Recall Bulletin

SUBJECT: Windshield Wiper Motor Failure

MODELS: 2016 Buick Enclave
2016 Chevrolet Traverse
2016 GMC Acadia

GM Recall #15780

4282670

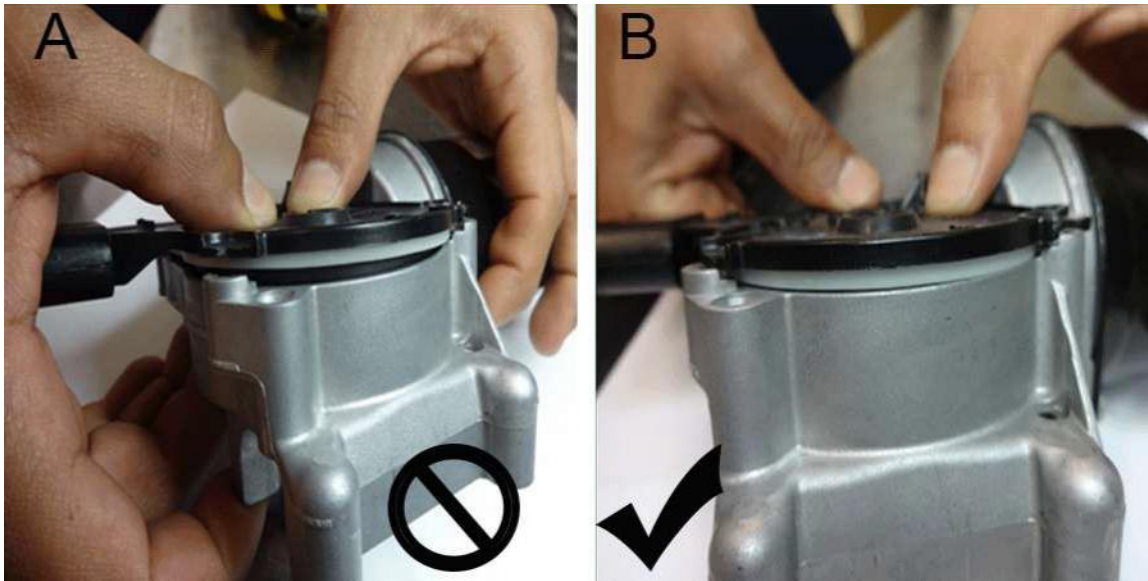
6. On the new wiper cover, align the sprocket (1) with the breather (2) as shown in the picture above.
